TSI-04-02-02

Subject: New Dana® Spicer® Steer Axle Hubcaps for Oil Applications

ABIB-0402

Topic: New Dana Spicer Steer and Trailer Axle Hubcaps for Oil Applications.

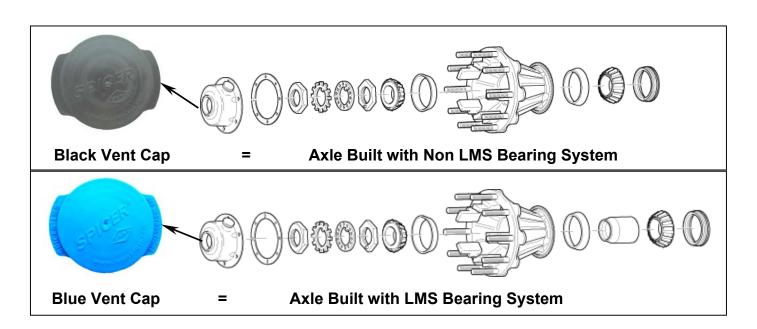
Dana Corporation's Commercial Vehicle Systems Division has released a new Low Maintenance Hubcap System (LMS) and will be made available for shipment beginning March 1, 2004. This hubcap and vent system will be available for aluminum and iron, oil-lubricated hubs. The LMS hubcap system is available for 10,000 through 22,000 lb. steer axle families, and both TP and TN spindle trailer axles ranging from 20,000 to 26,000 lb capacity.

This hubcap and vent system will identify to the service technician if the axle is equipped with a LMS or standard non-LMS wheel bearing system. The standard, non-LMS hubcap version is recognized by a black hubcap vent cap, while the LMS hubcap system is identified by a blue vent cap, with LMS identification tabs. The blue LMS vent plug can be used instead to replace the current LMS identification ring, as it exists today. See Figures below.
